## IEEE802.3 4P Task Force

November 2015

Yair Darshan/Microsemi

Comment [Annex 33A.5 Page 172 line 31]

Figure 33A-1- Example for PD common mode effective impedance calculation

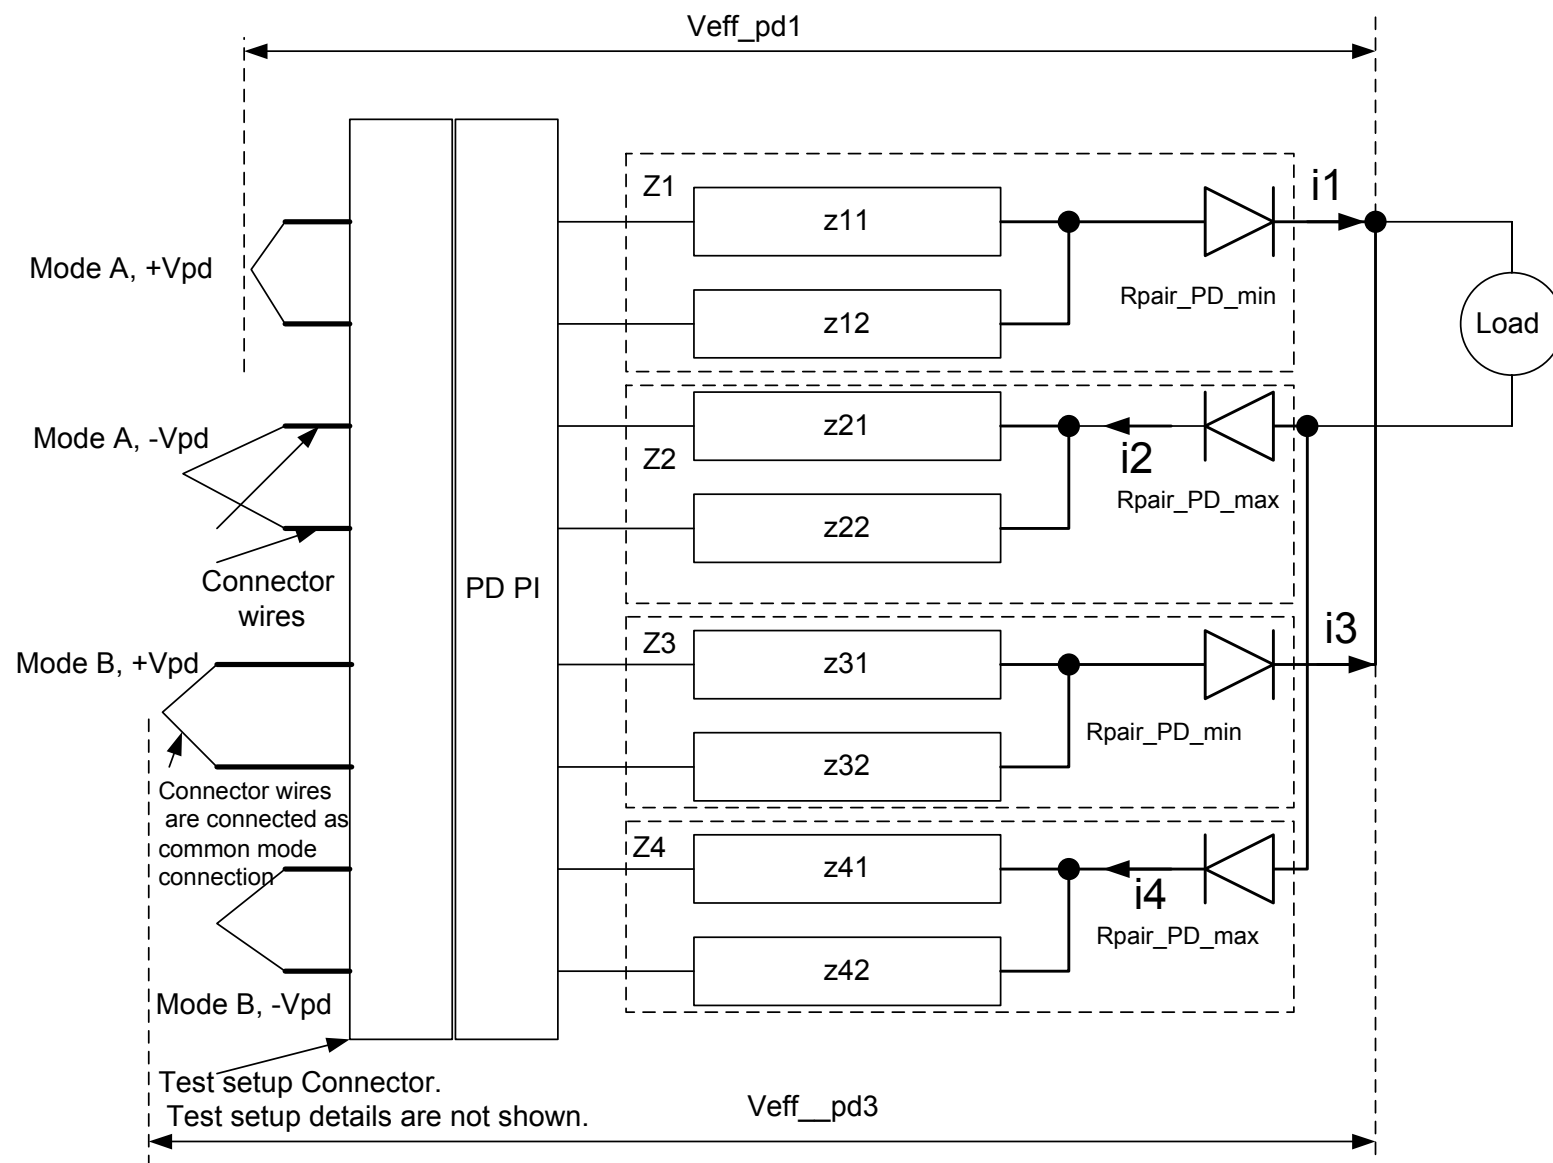
Requested by remedy of comment #5 from D1.3:

In Annex 33A.5 to define Rpair\_max\_PD, Rpair\_min\_PD.

**2. Add figure 33A-1 after the above text as described in page 3 of darshan\_01\_1115.pdf3.**

$R_{Pair\_PD\_max}$  and  $R_{Pair\_PD\_min}$  represent PD common mode input effective impedance of pairs of the same polarity.

The effective resistance  $Z_i$  is the measured voltage  $V_{eff\_pd\_i}$ , divided by the current through the path as described below and as shown in the example in Figure 33A-1.

Positive pairs:

$$Z1 = R_{Pair\_PD\_min} = V_{eff\_pd1}/i1$$

$$Z3 = R_{Pair\_PD\_max} = V_{eff\_pd3}/i3$$

Negative pairs:

$$Z2 = R_{Pair\_PD\_min} = V_{eff\_pd2}/i2$$

$$Z4 = R_{Pair\_PD\_max} = V_{eff\_pd4}/i4$$
